Test modes and loopbacks

Piers Dawe

Avago Technologies

Proposal for D1.2: 100G

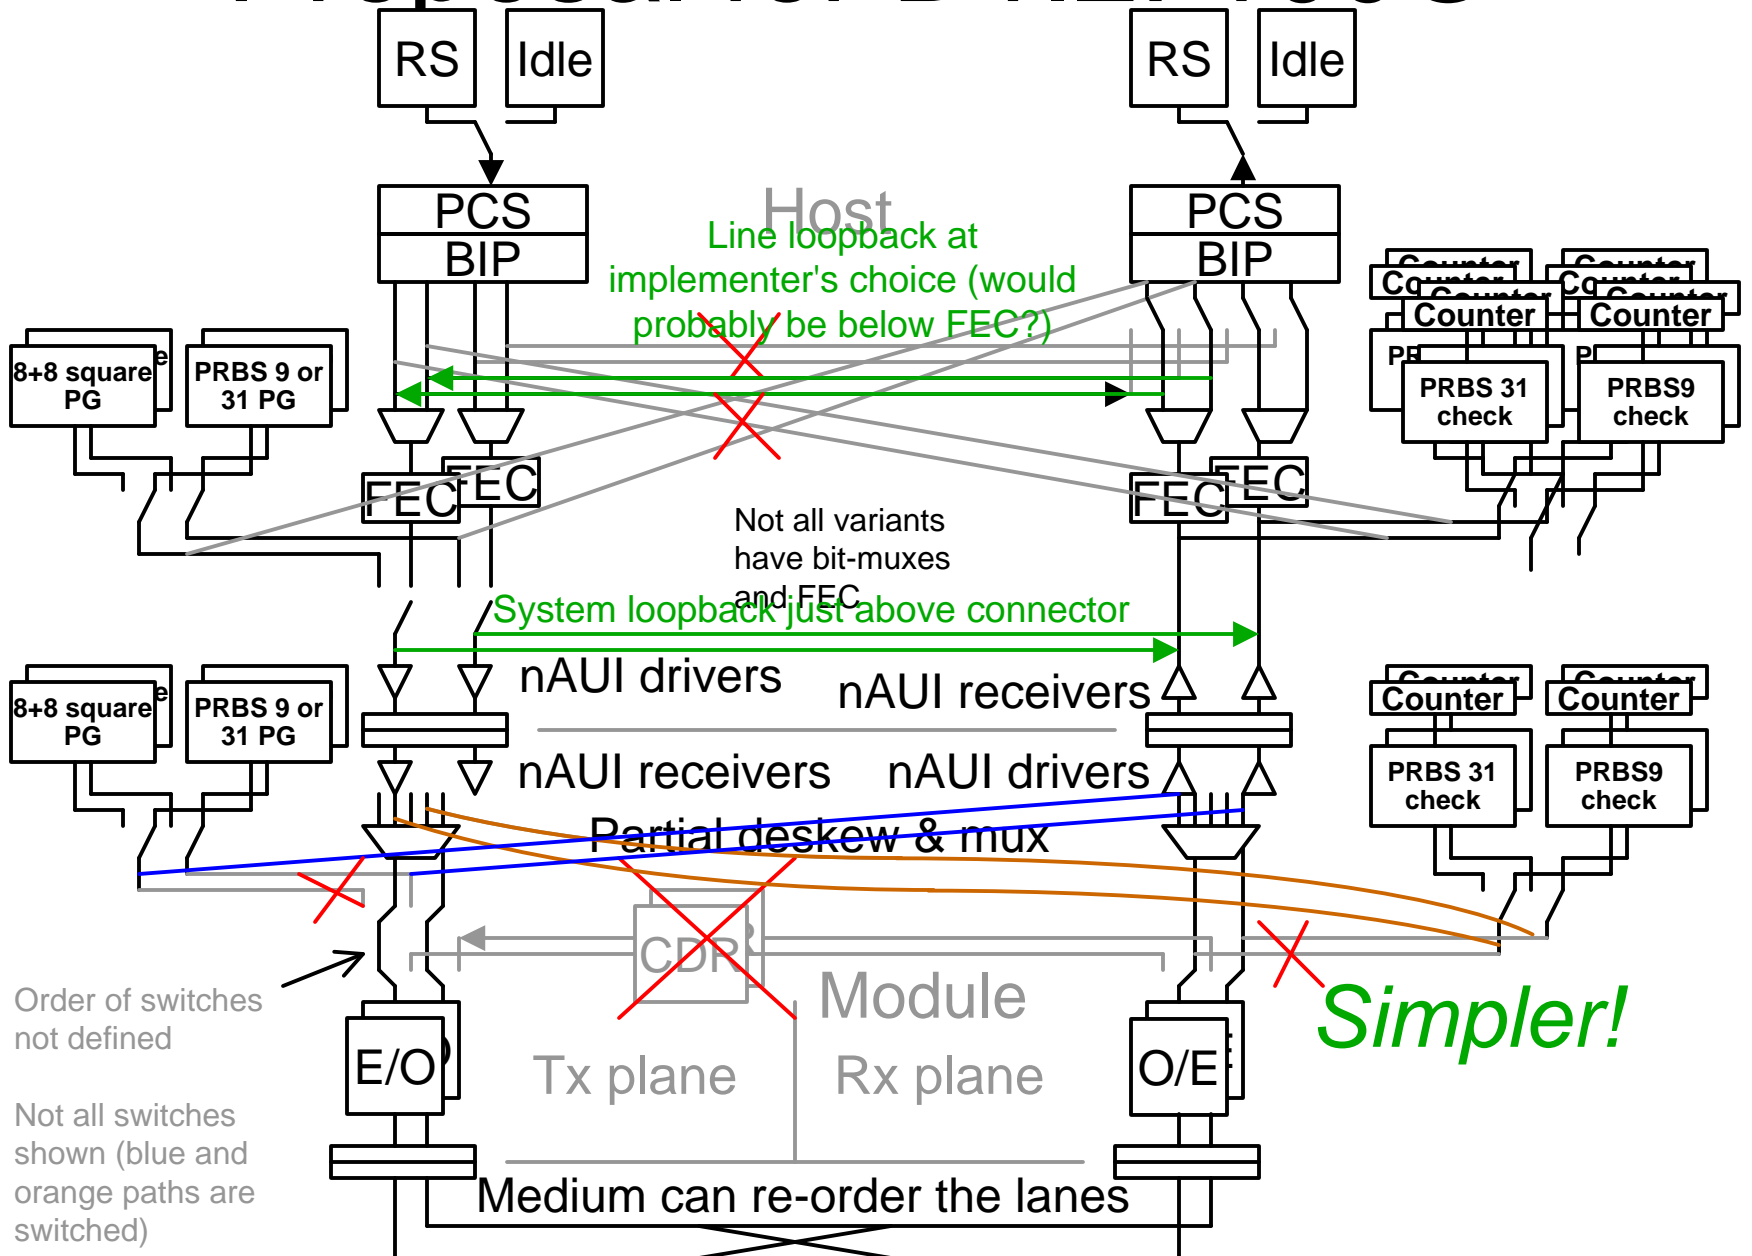
Order of switches not defined

Not all switches shown (blue and orange paths are switched)
